PSLTR-00-0057

Dresden Nuclear Power Station, Units 2 and 3  
Facility Operating License Nos. DPR-19 and DPR-25  
NRC Docket Nos. 50-237 and 50-249

Subject: Request for an Amendment to Technical Specifications Section 3 /4.6.K, "Primary System Boundary" and Section 3 /4.12.C "Special Test Exceptions" and Request for Exemption from 10CFR 50.60, "Acceptance criteria for fracture prevention measures for lightwater nuclear power reactors for normal operation."

FIGURE 3.6.K-1

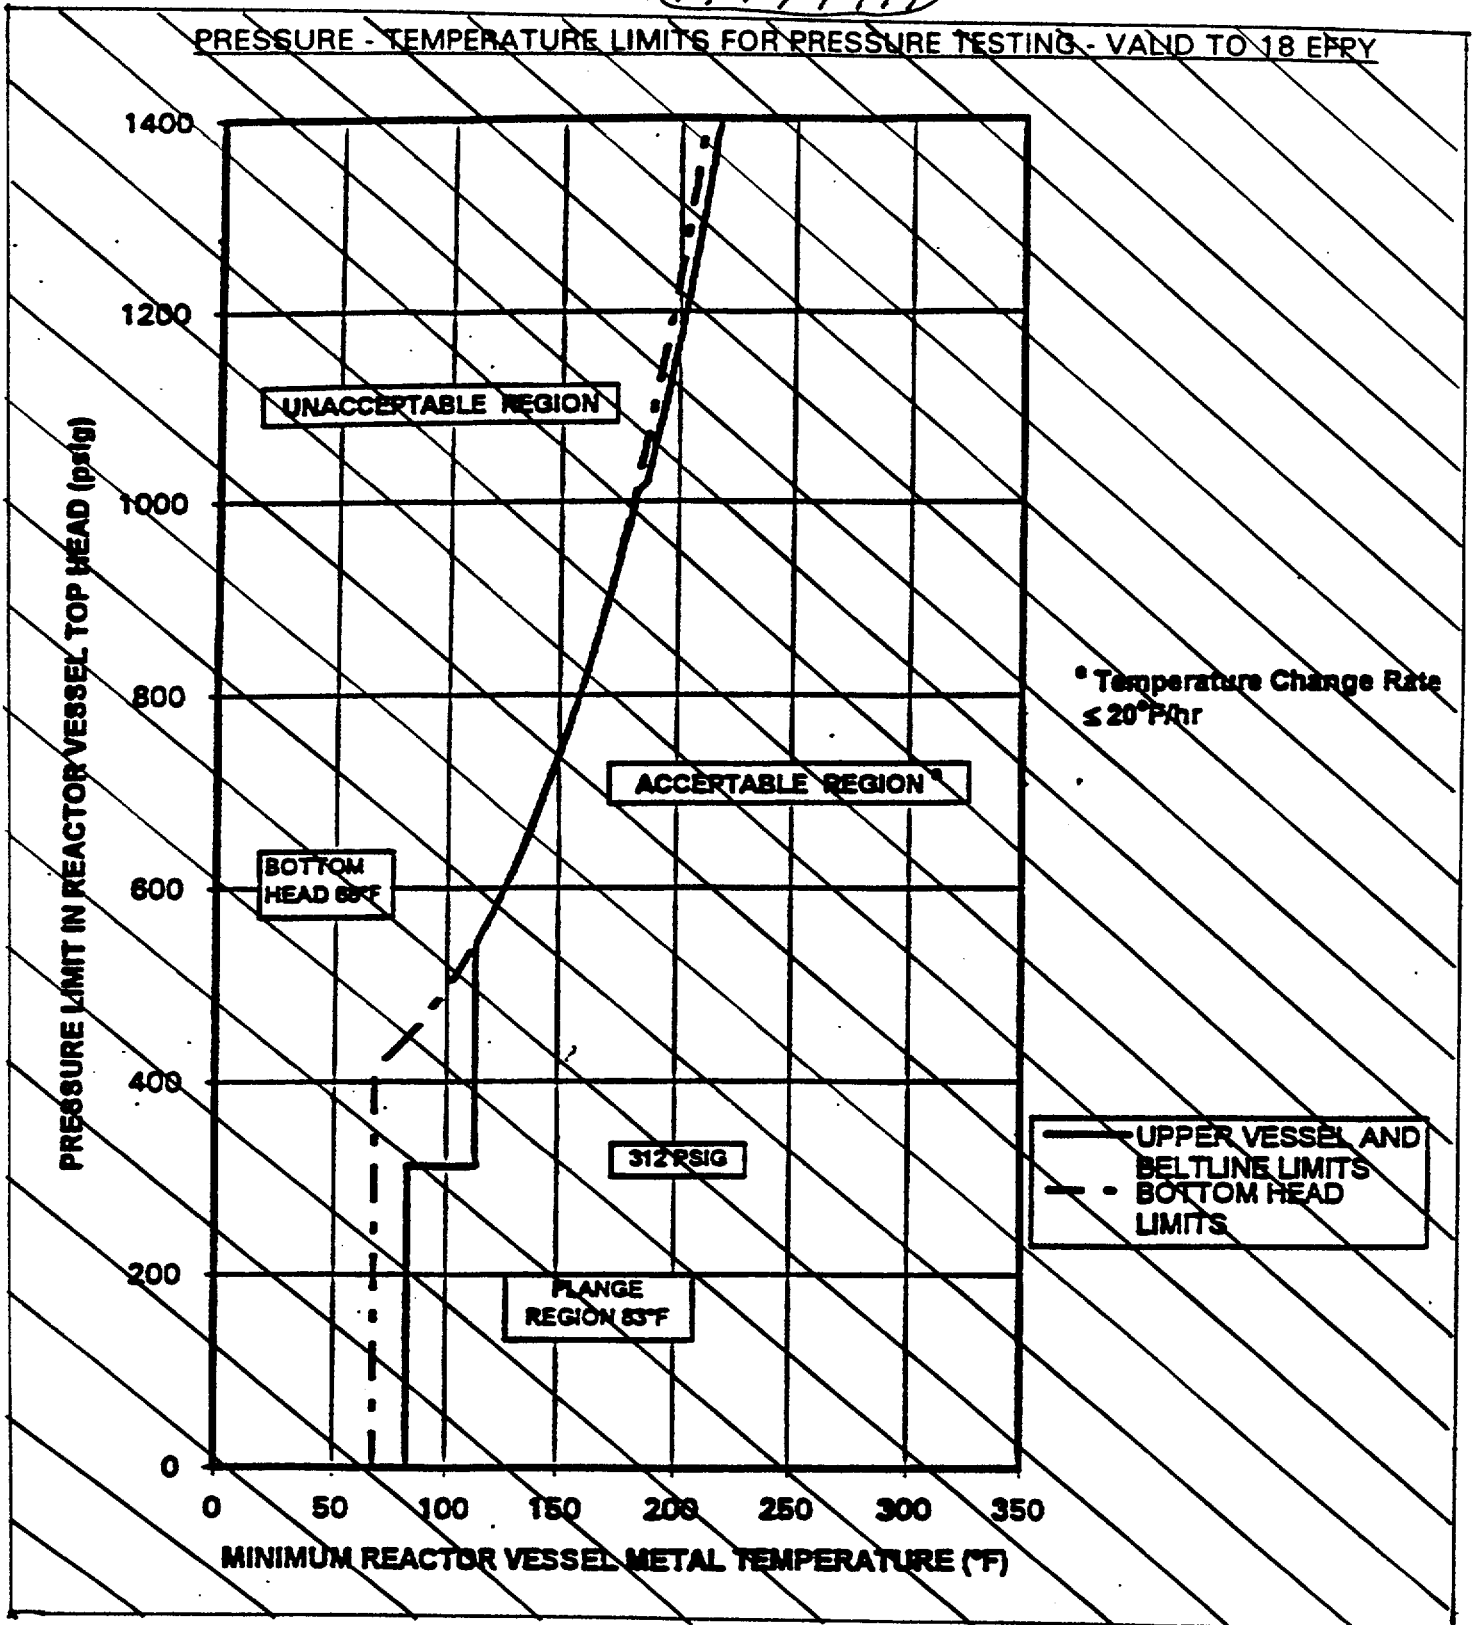
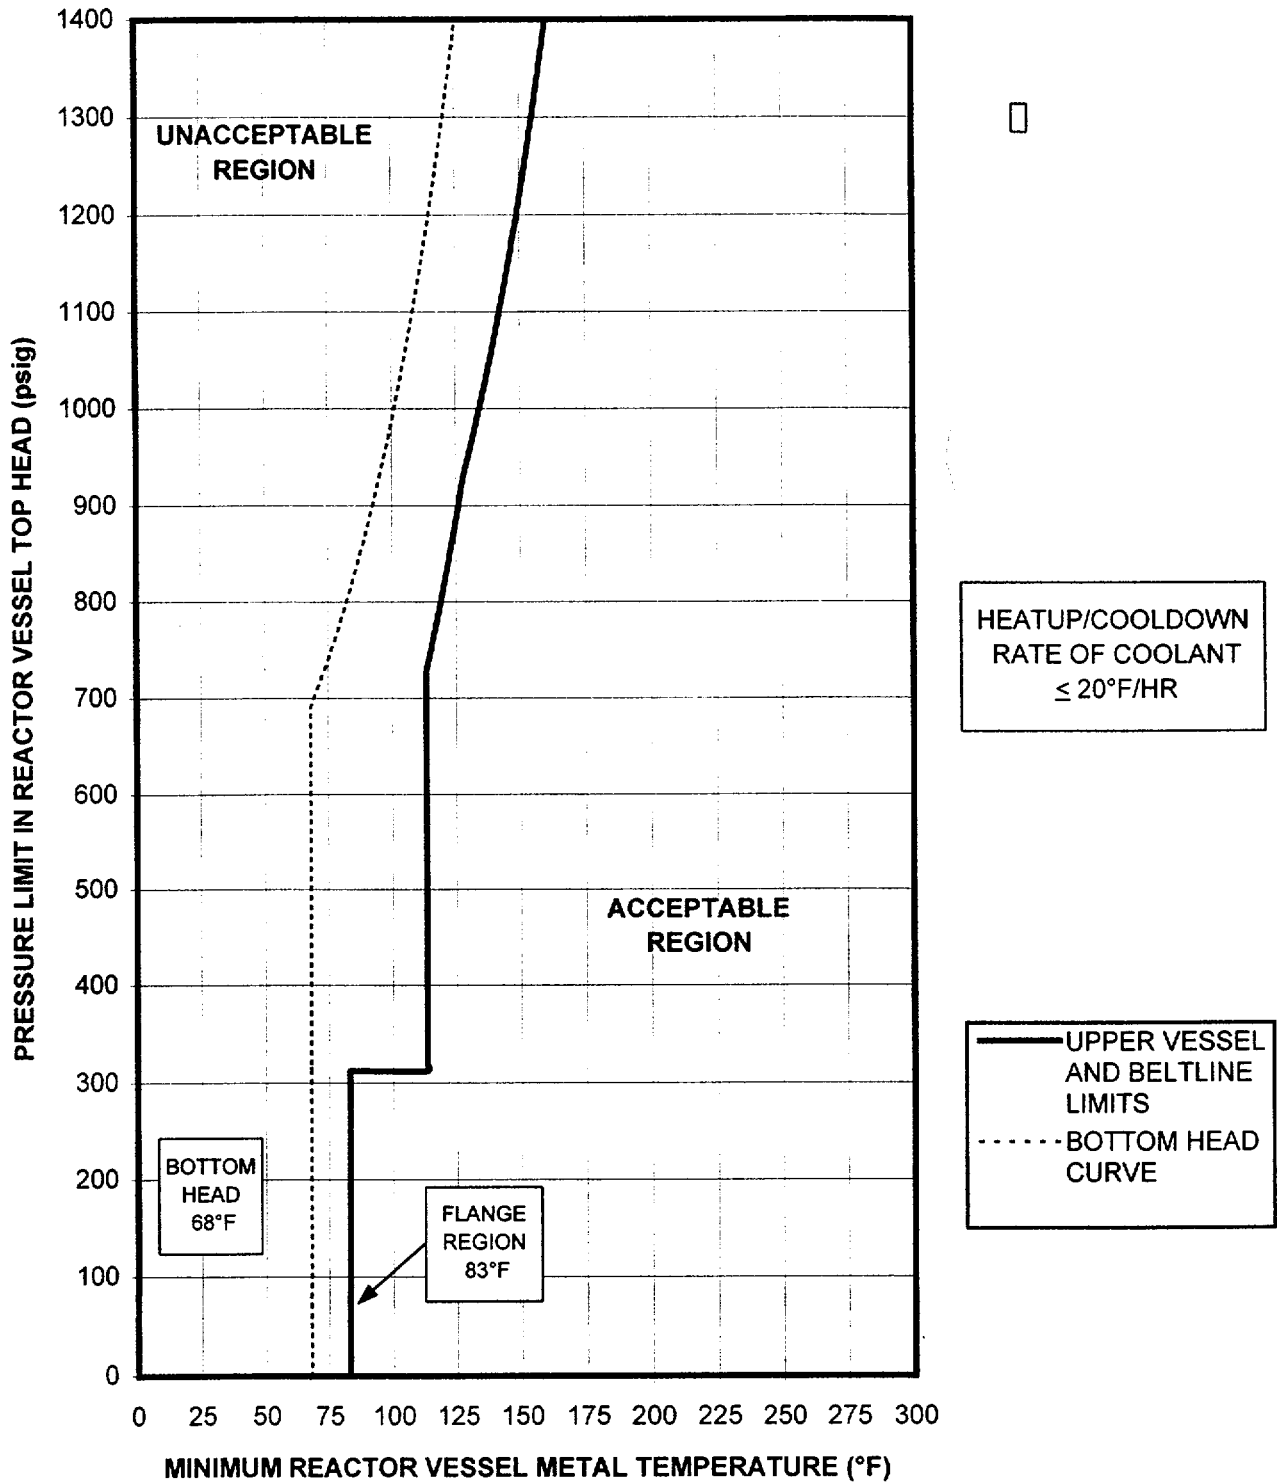
The proposed changes revise TS Figures 3.6.K-1 through 3.6.K-5, and delete the Special Test Exception for Inservice Leak and Hydrostatic testing operation. The proposed TS Figures 3.6.K-1 through 3.6.K-3 are bounding P-T curves for Unit 2 and Unit 3 RPVs.

- a. The reactor vessel metal temperature and pressure shall be maintained within the Acceptable Regions as shown on Figures 3.6.K-1 through 3.6.K-3 with the rate of change of the primary system coolant temperature  $\leq 20^{\circ}\text{F}$  per hour, or
- b. The rate of change of the primary system coolant temperature shall be  $\leq 100^{\circ}\text{F}$  per hour when reactor vessel metal temperature and pressure is maintained within the Acceptable Regions as shown on Figure 3.6.K-2.

PRESSURE - TEMPERATURE LIMITS FOR PRESSURE TESTING - VALID TO 32 EPY

FIGURE 3.6.K-2

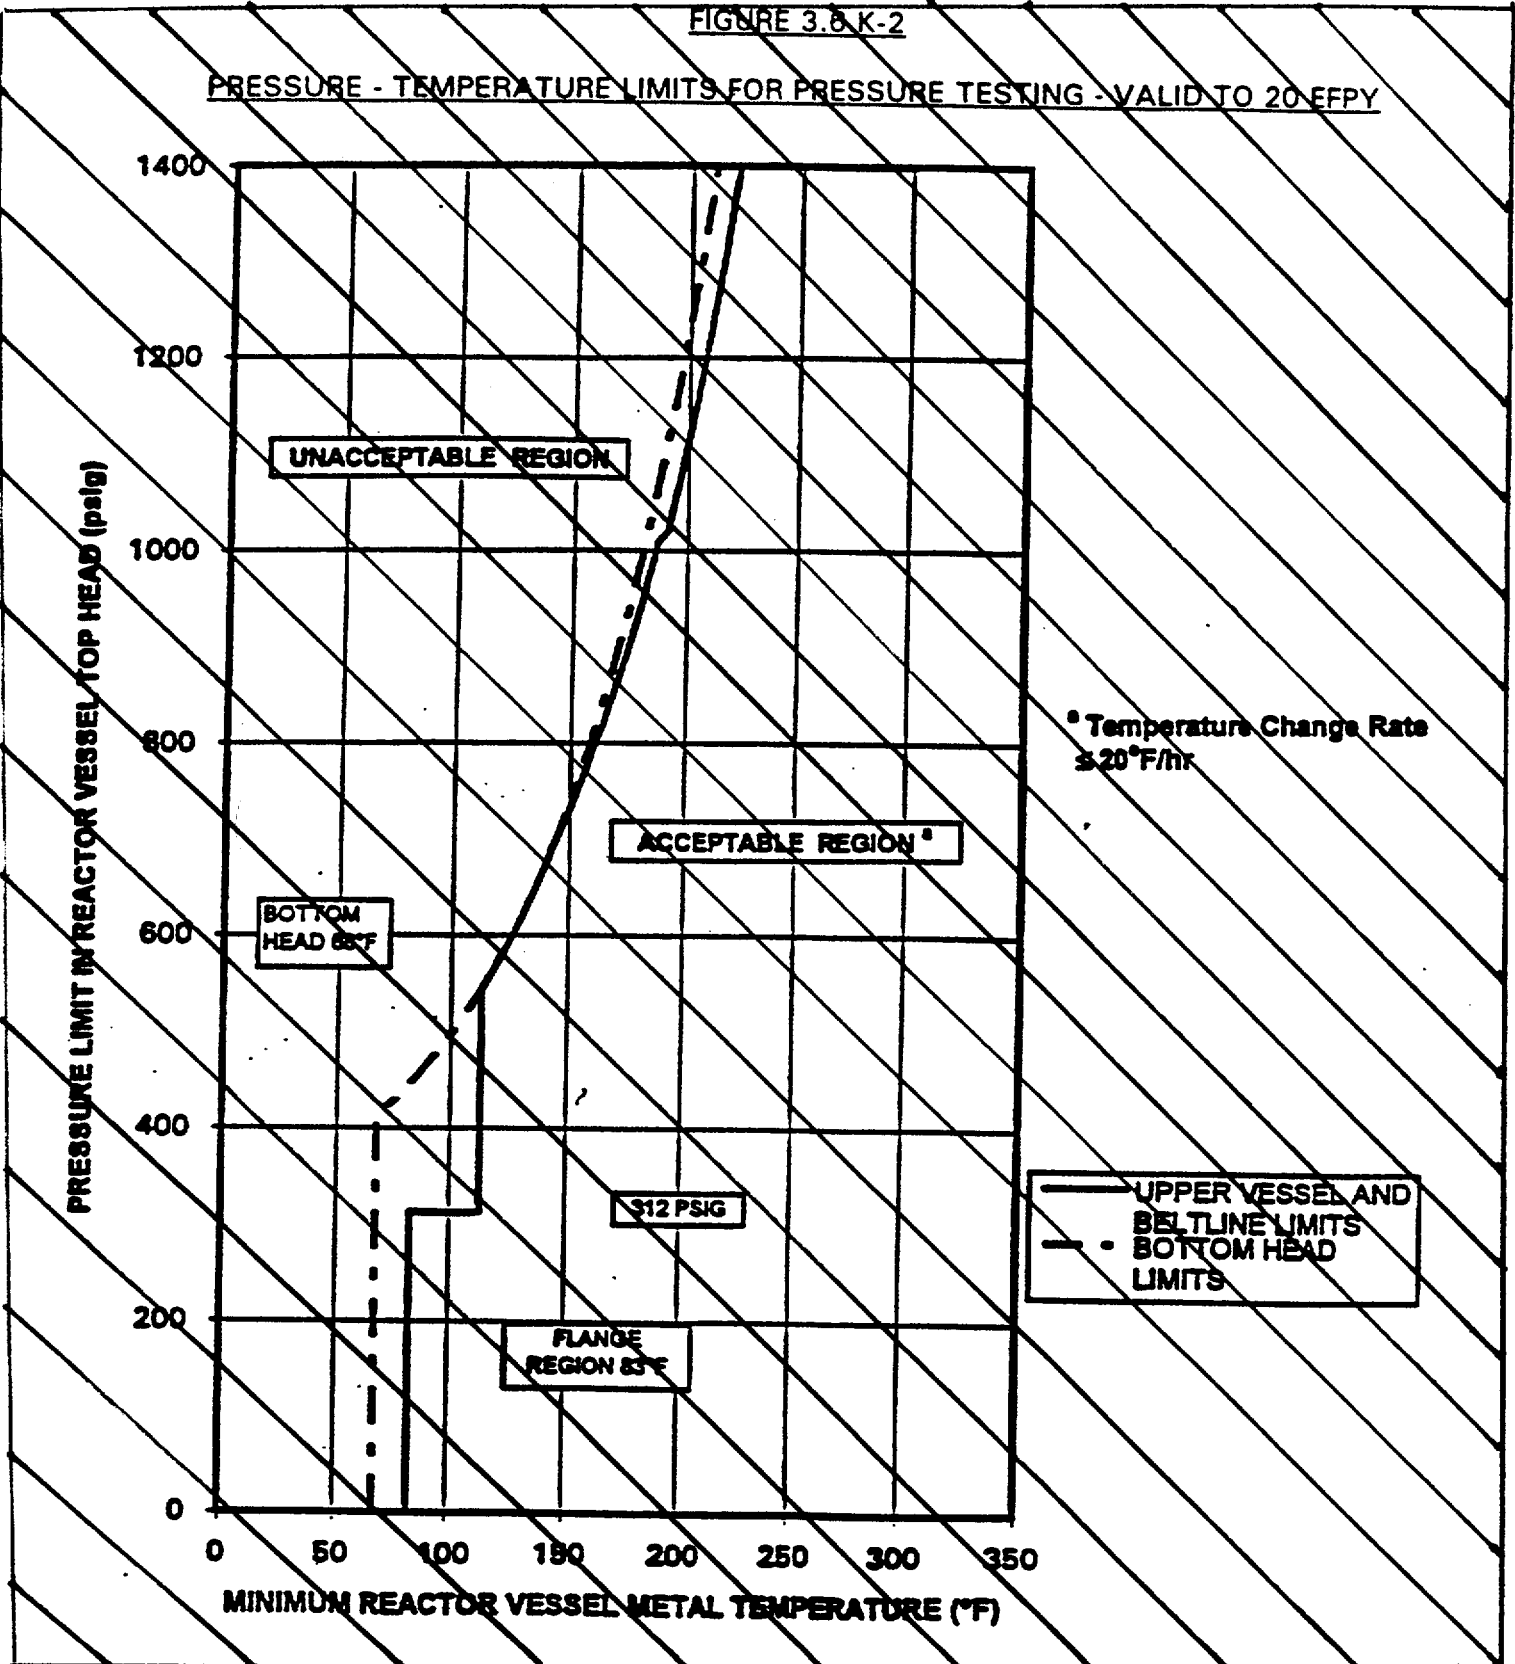
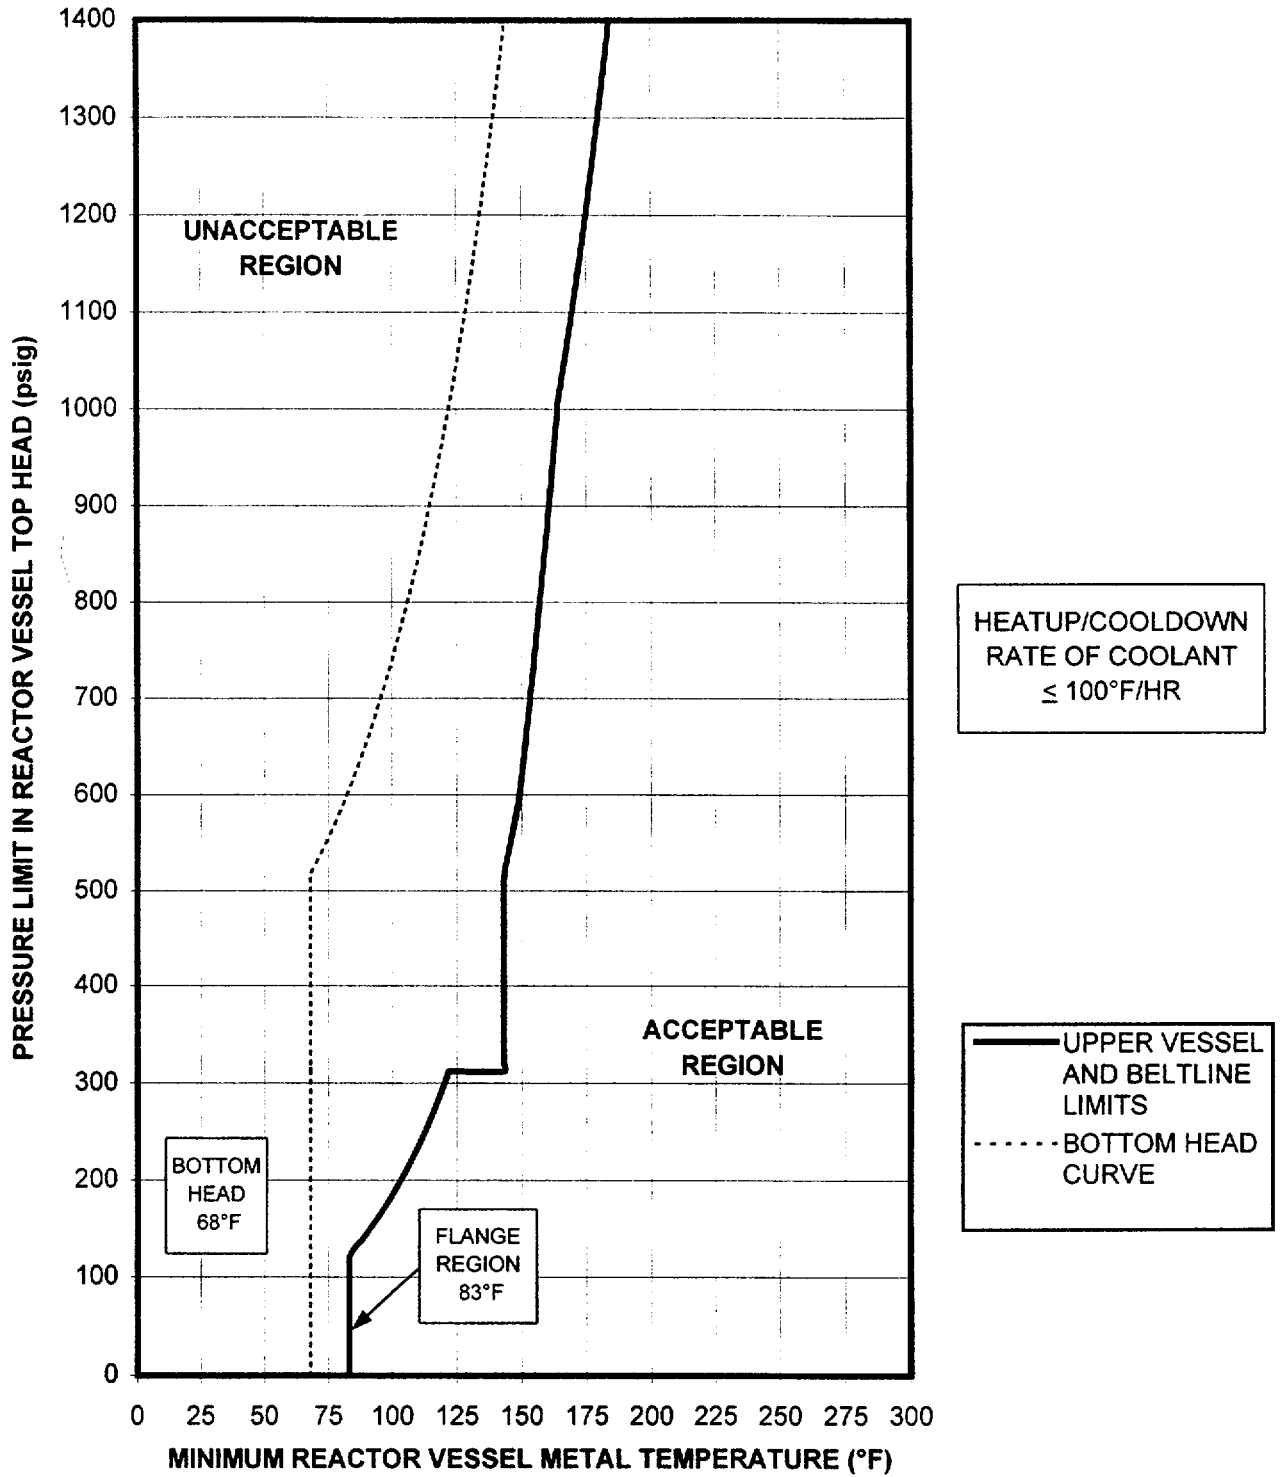
- a. The reactor vessel metal temperature and pressure shall be maintained within the Acceptable Regions as shown on Figure 3.6.K-2, and
- b. The rate of change of the primary system coolant temperature shall be  $\leq 100^{\circ}\text{F}$  per hour.

PRESSURE - TEMPERATURE LIMITS FOR NON-NUCLEAR  
HEATUP/COOLDOWN - VALID TO 32 EFPY
